Subject: Draft Safety Evaluation Report (SER) for Seabrook Station

## DRAFT

## REPORT (PARTIAL)

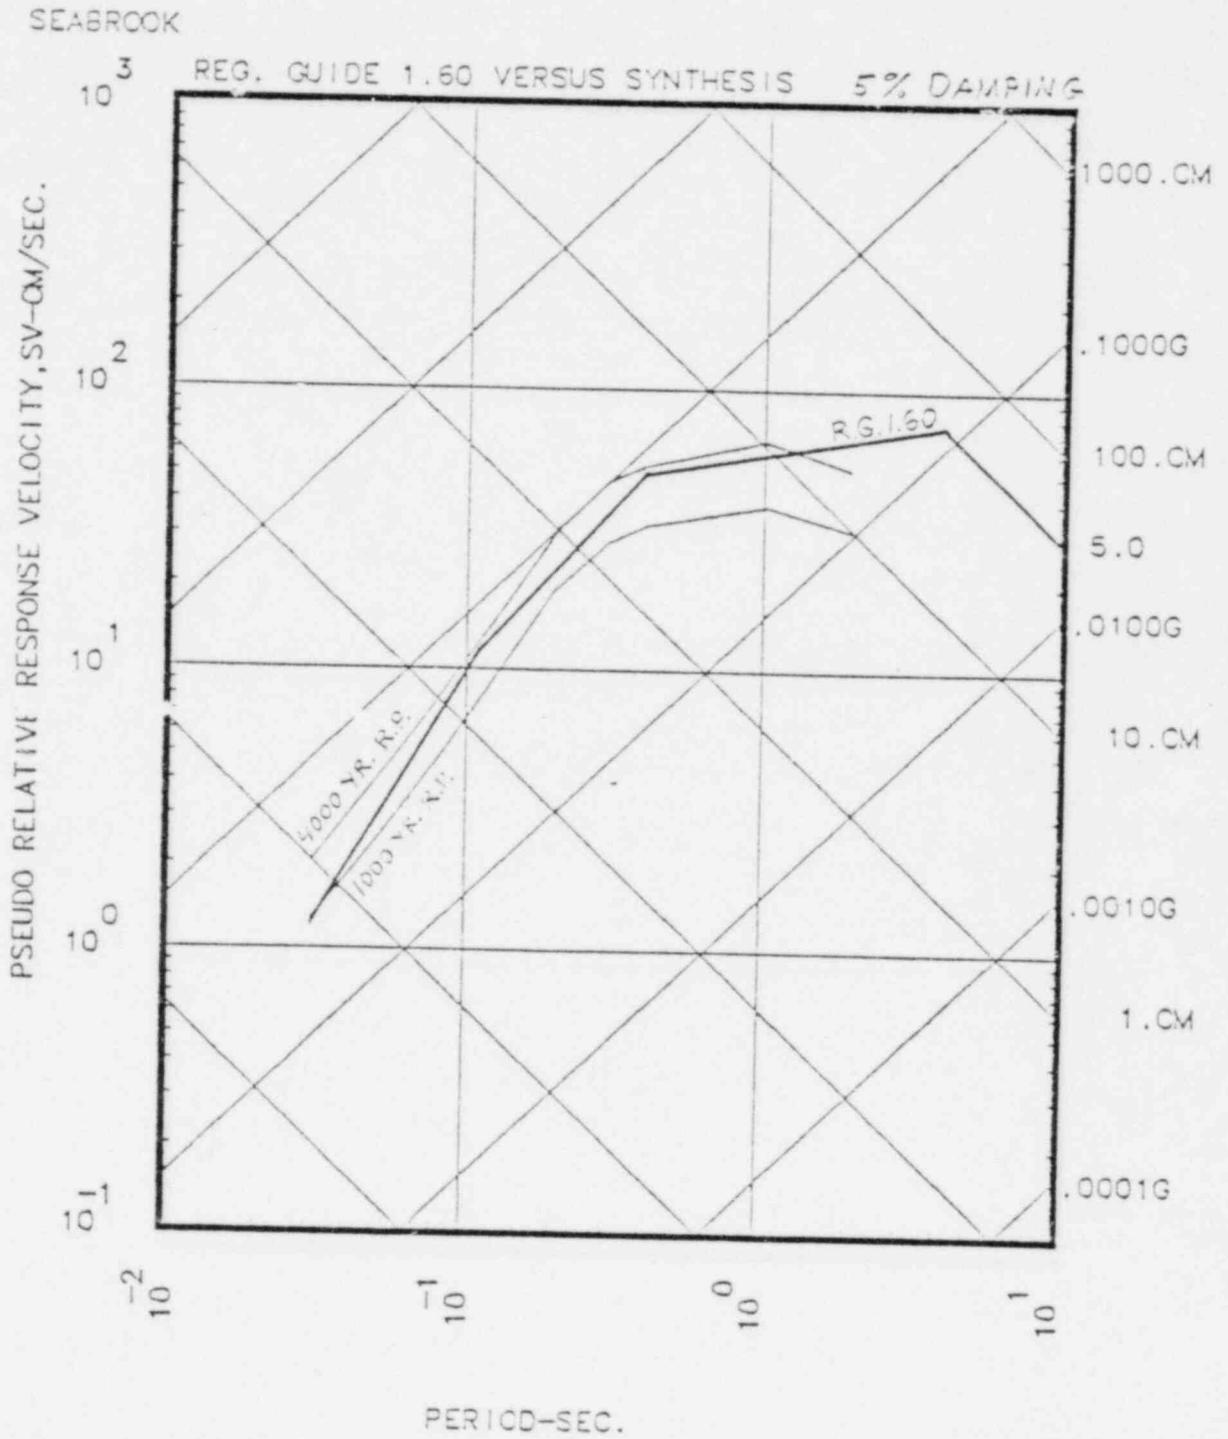
earthquake occurrence models, assuming several different attenuation relationships, then a single "synthesis" hazard spectrum was calculated using a complex weighting scheme using self weights supplied by the individual experts. In Figure 2.5-3 the Seabrook SSE response spectrum is plotted with the synthesis LLNL uniform hazard spectra (5% damping) for "1,000 year" and "4,000 year" return periods, assuming the Ossippee attenuation relationship. The Ossippee attenuation model is based on data from the 1940 Lake Ossippee, New Hampshire earthquakes and has been recommended previously by the staff for use in determining ground motion in the northeastern U. S. (Jackson, 1980).

Figure 2.5-3 shows that the Seabrook SSE spectrum falls between the synthesis curves for a "1000 year" return period and a "4000 year" return period and, thus, that the return period (inverse of annual risk of exceedance) for the SSE lies between 1,000 and 4,000 years. For a number of reasons (Jackson, 1980), the staff believes that "1000 year spectra," generated by the SSSP methodology, are conservative and represent loads with true return periods greater than 1,000 years. Design spectra that were assumed to have return periods on the order of 1,000 to 10,000 years have been accepted implicitly by the NRC in recent licensing decisions (Jackson, 1980).
